Re PART 3A APPLICATIONS FOR GRAYTHWAITE SITE, EDWARD STREET NORTH SYDNEY

## **GRAITHWAITE PART 3A CONCEPT PLAN AND PROJECT APPLICATION**

(Reference MP – 0149 and MP – 0150)

### **SUBMISSION TO THE NSW DEPARTMENT OF PLANNING**

*Figure 1: North Sydney Council's proposed height controls for the Shore School/Graythwaite site*

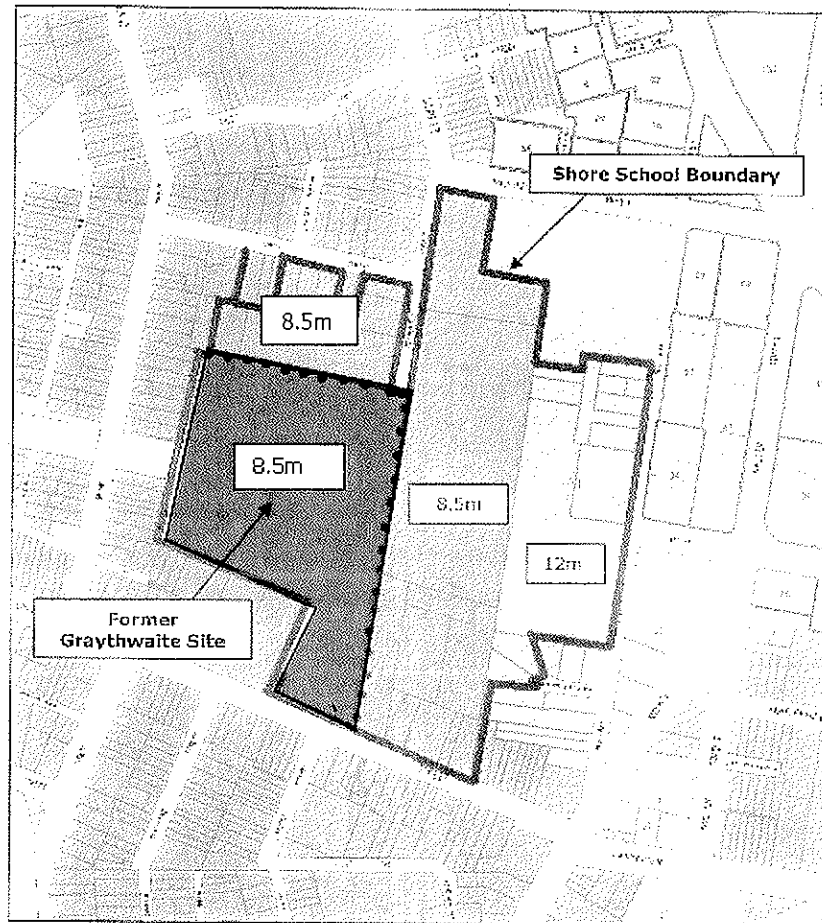
The Department supports Council's request that 12m and 8.5m height limits be conditioned for the Shore School site, and that an 8.5m height limit be conditioned for the former Graythwaite site in accordance with Figure 1 below.

**Figure 1:** Maximum building heights for Shore School and incorporated Graythwaite site

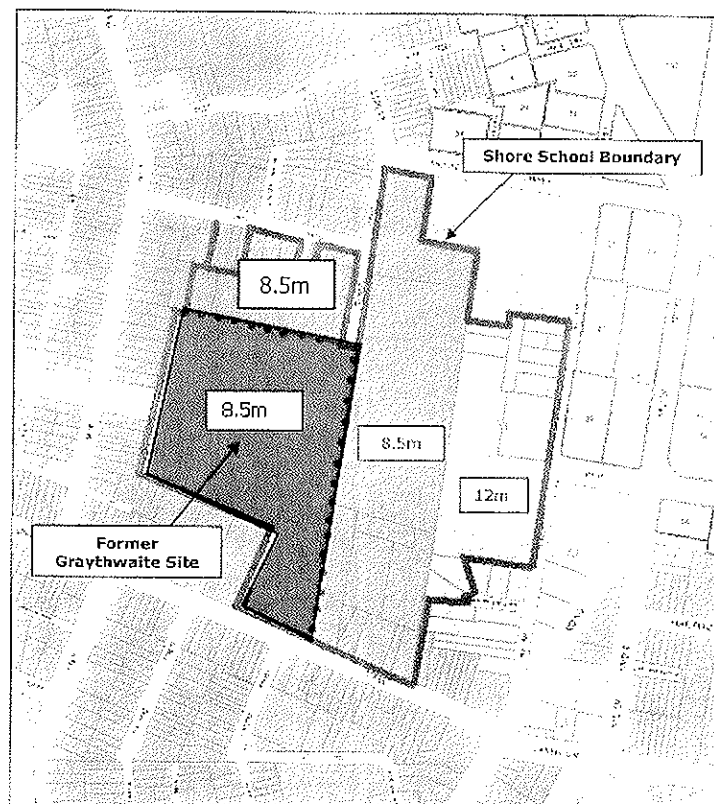
- 13) Insert draft model clause 7.4 - Airspace Operations into the DLEP.
- 14) Amend the Height of Buildings Map - Sheet HOB\_005 to show maximum building heights of 12m and 8.5m for the Shore School and incorporated Graythwaite site as shown Figure 1

## 3D Images of Proposed West Building

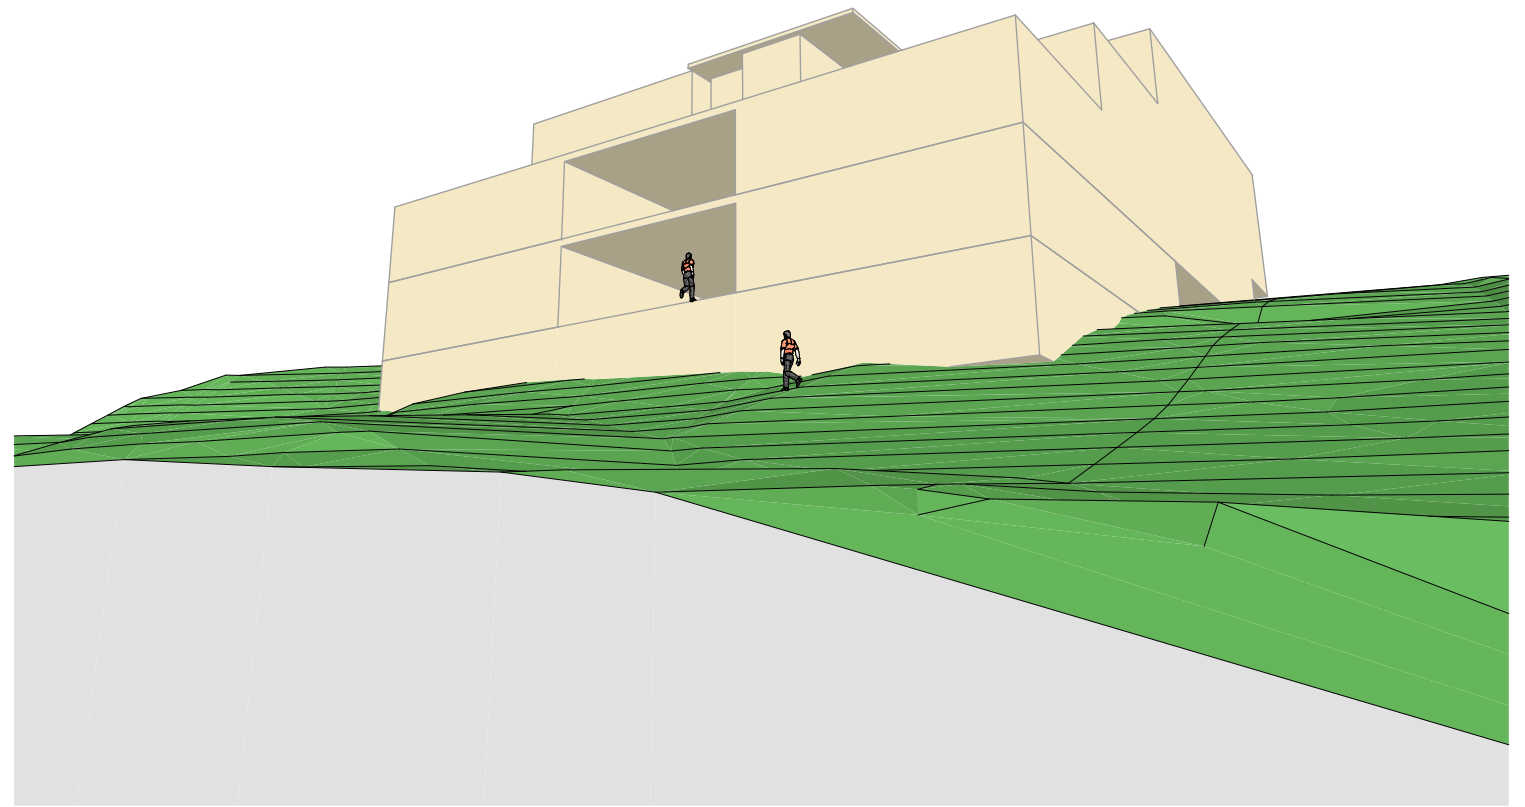
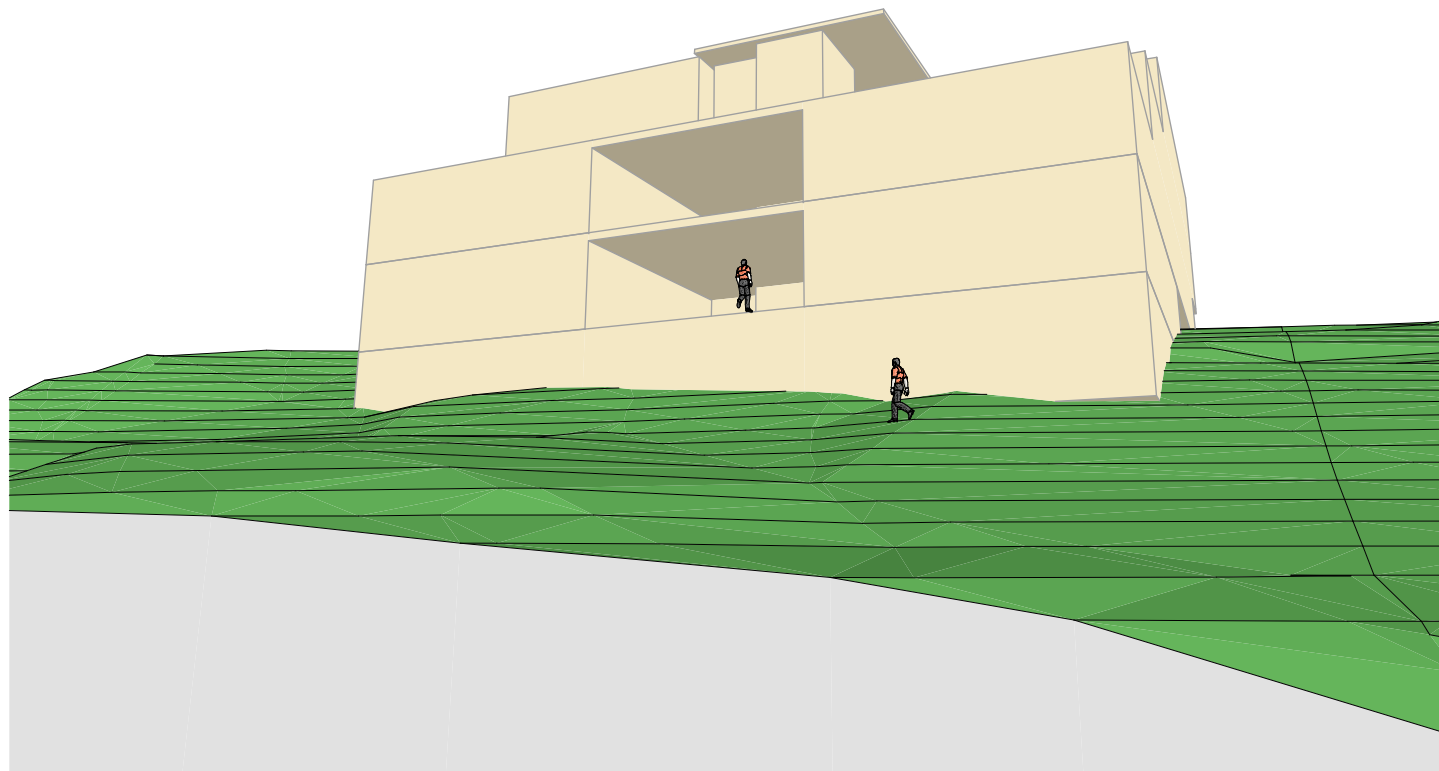
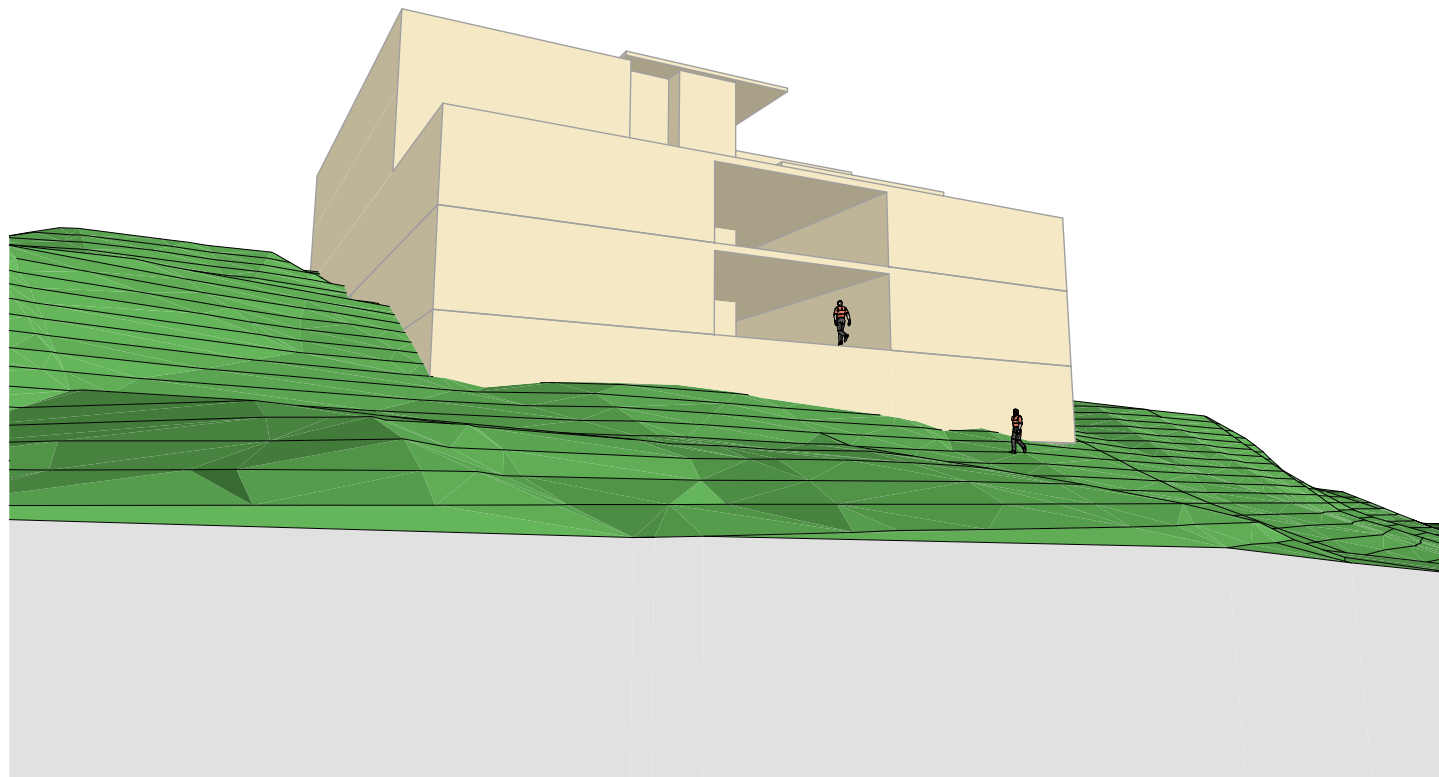
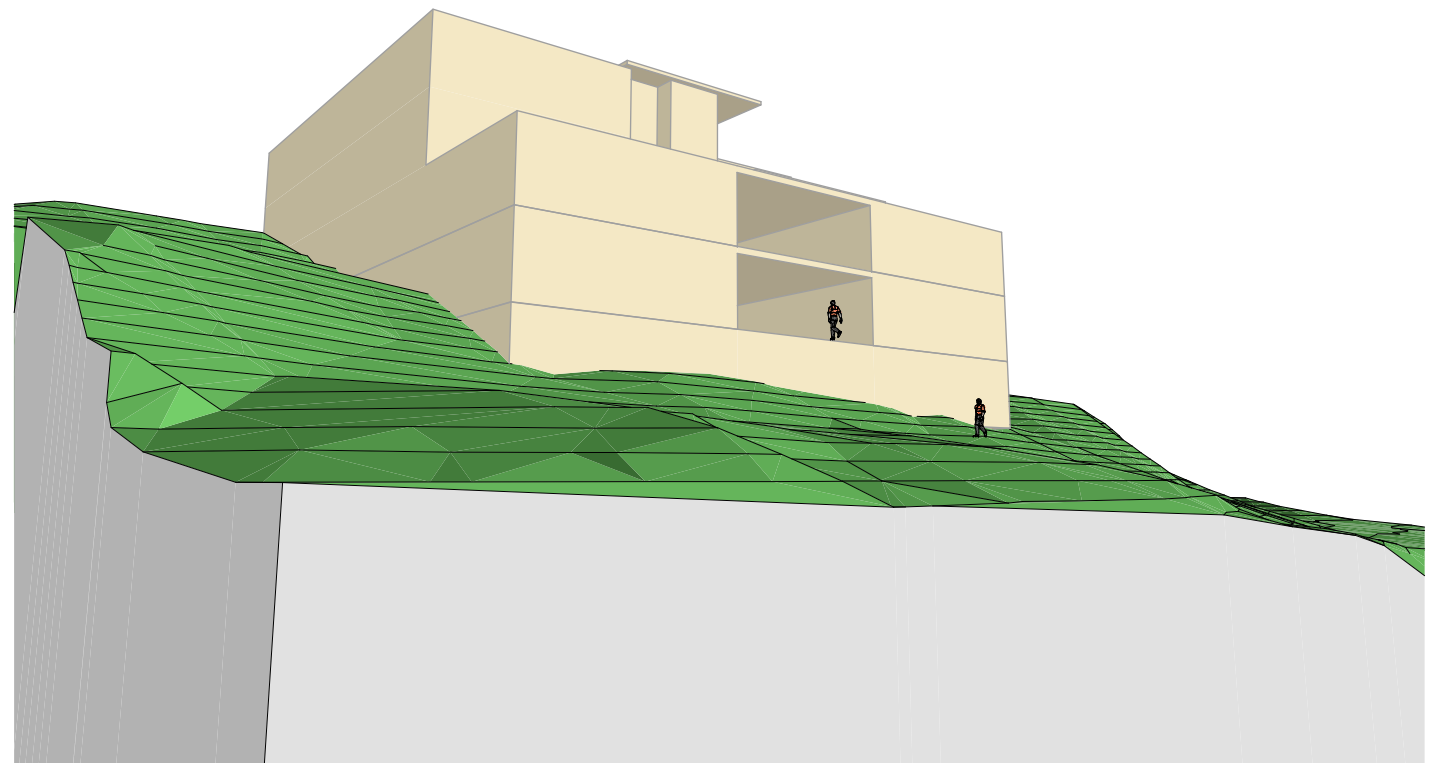
The acceptability is said to arise from the setback of the building from the property boundary, the distance being comparable to the rear dwelling setbacks of many of those houses, the stepping of the building down the slope and its height of two storeys at the western end, and the proposed planting. The three community groups contest this dismissive “assessment”. The impact on these dwellings will be significant and is unacceptable because;

- Whilst the proposed planting will help it is still insufficient to alone mitigate the impact of such a massive building on these relatively tiny residential buildings down the slope.

The increased setback of the West Building and its reduction in size and height, as proposed above in 9.3 above to help mitigate its visual impact will however have the added benefit of reducing the shadow impacts to an acceptable level, further supporting those recommendations.
